Project	<b>IEEE 802.16 Broadband Wireless Access Working Group</b> < <a href="http://ieee802.org/16">http://ieee802.org/16</a> >	
Title	<b>Anonymous Initial Ranging</b>	
Date Submitted	<b>2002-07-01</b>	
Source(s)	Robert Nelson Raze Technologies Inc 2540 E Plano Pkwy Suite 188	Voice: (972) 516-1283 Fax: (972) 578-9081 <a href="mailto:bnelson@razetechnologies.com">[mailto:bnelson@razetechnologies.com]</a>
Re:	Working Group Letter Ballot #7  "Draft Amendment to IEEE Standard for Local and Metropolitan Area Networks –Part 16:Air Interface for Fixed Broadband Wireless Access Systems – Medium Access Control Modifications and Additional Physical Layer Specifications for 2-11 GHz "	
Abstract	This contribution presents a mechanism for allowing dialog to take place between the base station and a subscriber performing initial ranging, before the base station is able to decode Ranging Request messages transmitted by the subscriber.

# Anonymous Initial Ranging

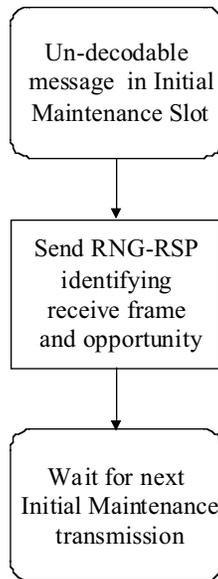
Add the following to Figure 51 in the base document:
